SERVICE BULLETIN #124

04/14/14

3562 Spoke Wheel

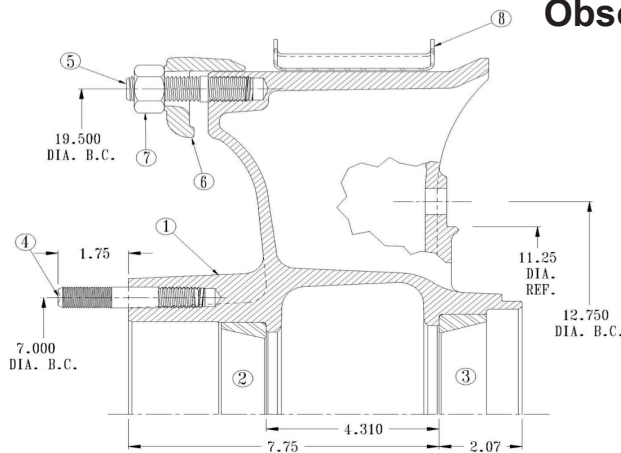
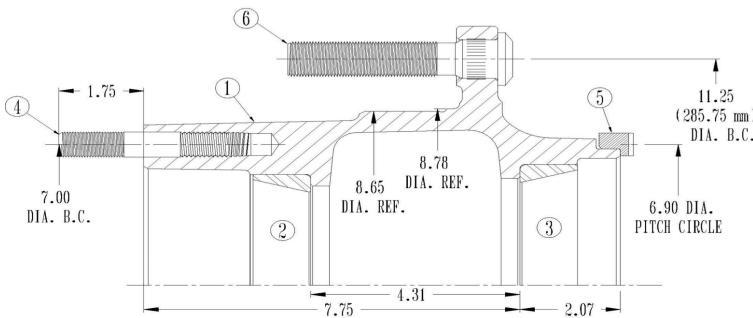
Upon depletion of inventory, the 3562 spoke will become obsolete with no direct replacement. We do however recommend a replacement: the 10-stud 2643 hub. This requires changing brake drums, changing to a disc hub, and changing to disc wheels instead of demountable rims. If you have any questions, please contact the Webb Engineering department via email to engineering@webbwheel.com or call 256-736-6356.
